Report Committee of Adjustment

File: A-2023-0379

Address: 51 Sutter Avenue

Contact: Ramsen Yousif, Development Planner

Appendix A – Concept Plan

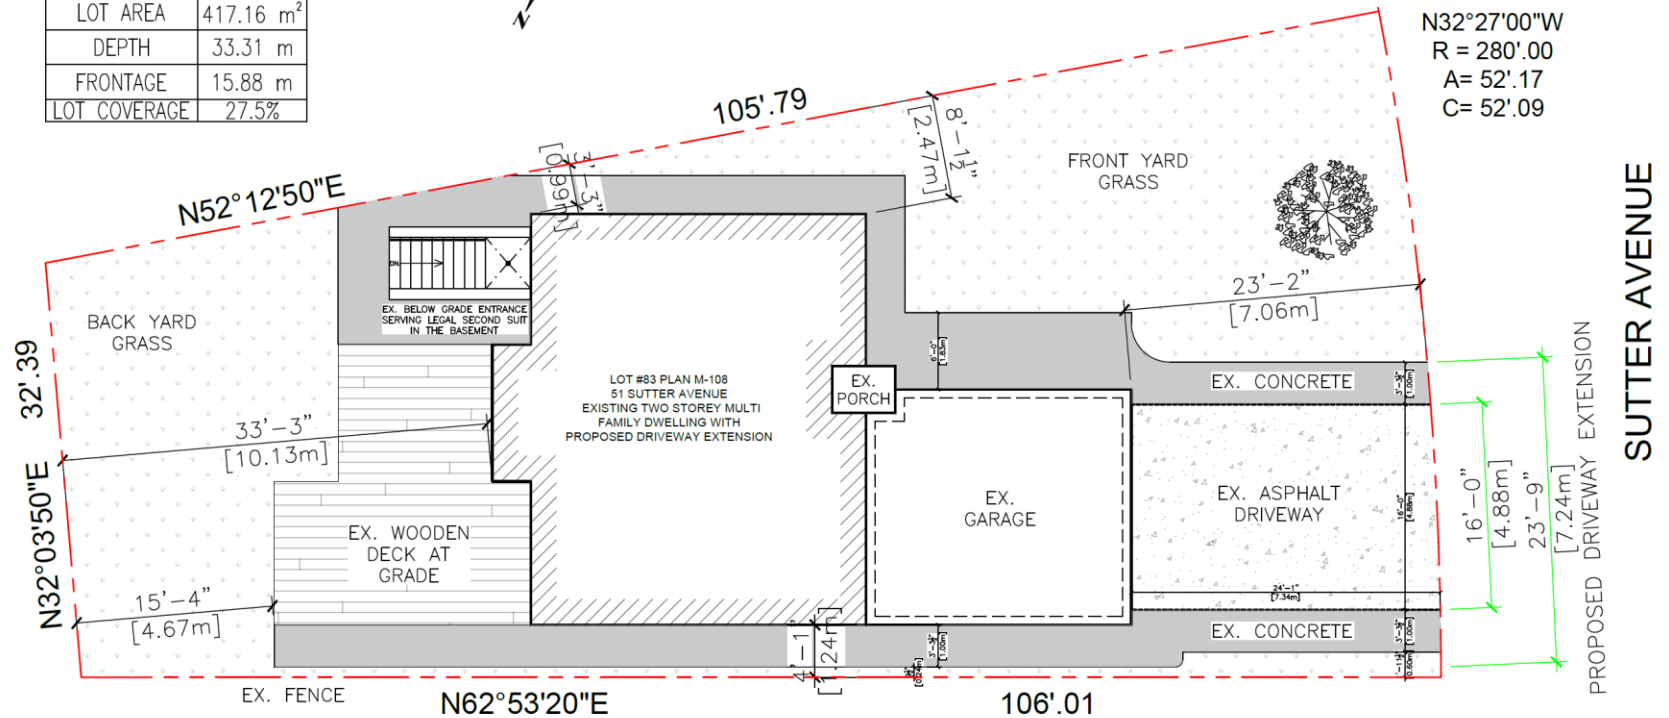
The existing driveway was widened on both the eastern and western portions of the lot, allowing for a total driveway width of 7.77 metres (25.49 feet) at its widest point which equates to 1.06 metres (3.44 feet) more than what the by-law permits. Following discussions between Planning staff and the applicant, a revised sketch was provided depicting a proposed reduction to the total driveway width.

The requested variance is now revised to permit a driveway width of 7.24 metres, whereas the by-law permits a maximum driveway width of 6.71 metres. Based on a site visit conducted by staff, Staff are of the opinion that a sufficient amount of open landscaping remains in the front yard should the driveway width be reduced to 7.24 metres. Staff further note that the reduced permeable landscaping only relates to a small portion of the driveway while a majority of permeable landscaping remains in compliance with the by-law. In the case of the subject property, the existing driveway leads to the dwelling's two car garage and includes a minimized wider portion that is intended to be used as a walkway to the rear yard which is reflected in the overall concrete design. The existing site configuration is supportable due to the abundance in permeable materials across the site. Subject to the recommended conditions of approval, Variances 1 and 2 are considered to maintain the general intent of the by-law.

Following staff concerns regarding the initial minor variance amendment for 7.77m, staff actively engaged and collaborated with the applicant. The objective was to address the potential issue of excessive vehicle parking and reduce the opportunity for vehicles to be parked in close proximity to the street tree. Consequently, the proposed width was revised to 7.24m to mitigate these concerns. The applicant worked with staff to amend the original minor variance and submitted a revised sketch indicating a reduction in the proposed extension on the east side of the driveway from 1.52m to 1.00m. Staff is satisfied with the amendment made by the applicant to the driveway extension.

1. That the extent of the variance be limited to that shown on the revised sketch (Appendix A) attached to the Notice of Decision;
 2. That a maximum driveway width of 7.24m (23.75 ft.) be permitted in accordance with the revised concept plan (Appendix A);
 3. That the extended portion of the driveway shall not be parked or driven upon at any time by the whole or a part of the motor vehicle; and
 4. That failure to comply with and maintain the conditions of the Committee shall render the approval null and void.
-
